MEMO

Department of Water Resources

To: Water Right File 63-33721 / *App for Permit / (Transfer 78338-43-2958 + 43-31988)*

Subject: Review of memorandum from Sherl Chapman (Chapman) dated November 17, 2013 in support of a petition to reconsider the permit for Hoot Nanny Farms, Inc.

North Ada County Monitoring Well #3 T. 4 N., R. 1 W., Section 04

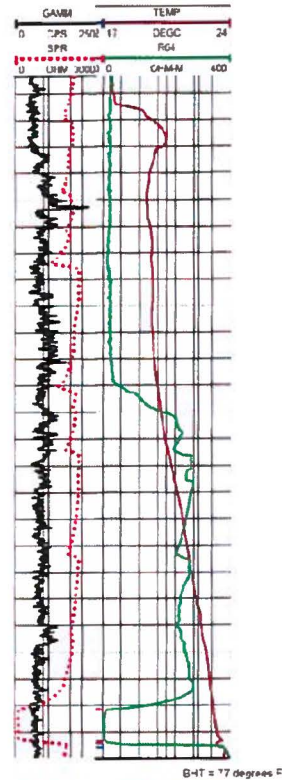
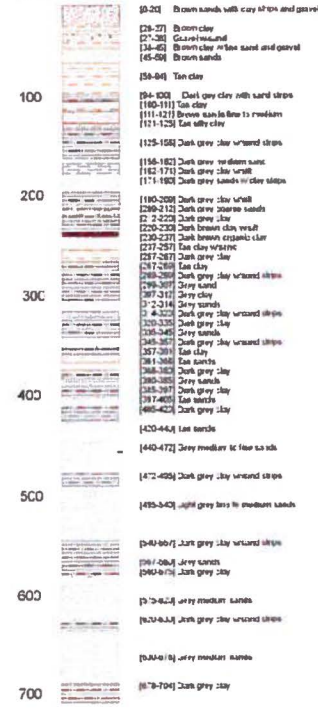
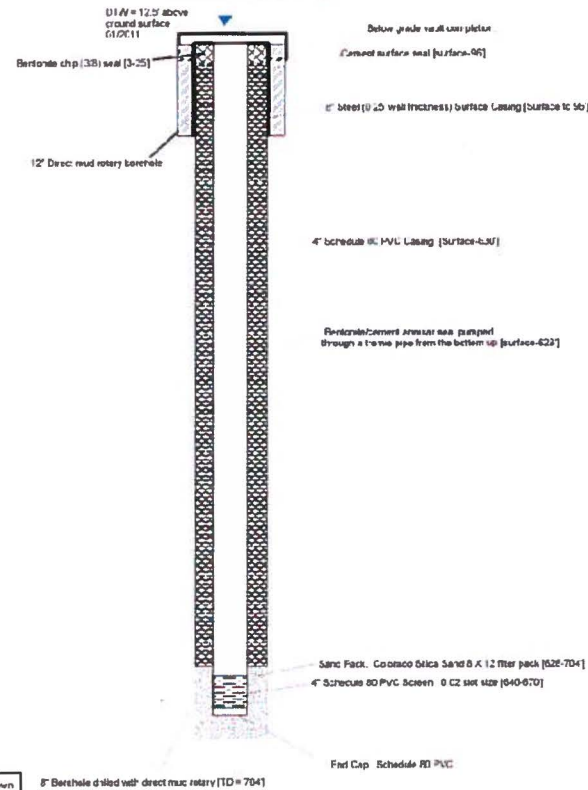
However, since the applicant has agreed to case and seal the production well to 125 feet deep, the maximum open interval for a 200-foot well is only 75 feet, rather than 150 feet as contemplated in the March, 2013 report. Nonetheless, the applicant has not provided any geologic or aquifer testing information to support the assertion that the interval from 125 feet to 200 feet would fail to provide an adequate water supply. Moreover, the cross-section included in the Chapman report depicts a dipping sand horizon between 125-200 feet below land surface in the four wells closest to the proposed production well. One of those wells, a monitoring well located one-half mile to the southwest of the proposed production well that was installed by the Department, encountered approximately 25 feet of sands between the depths of 156 and 190 feet (Appendix A).
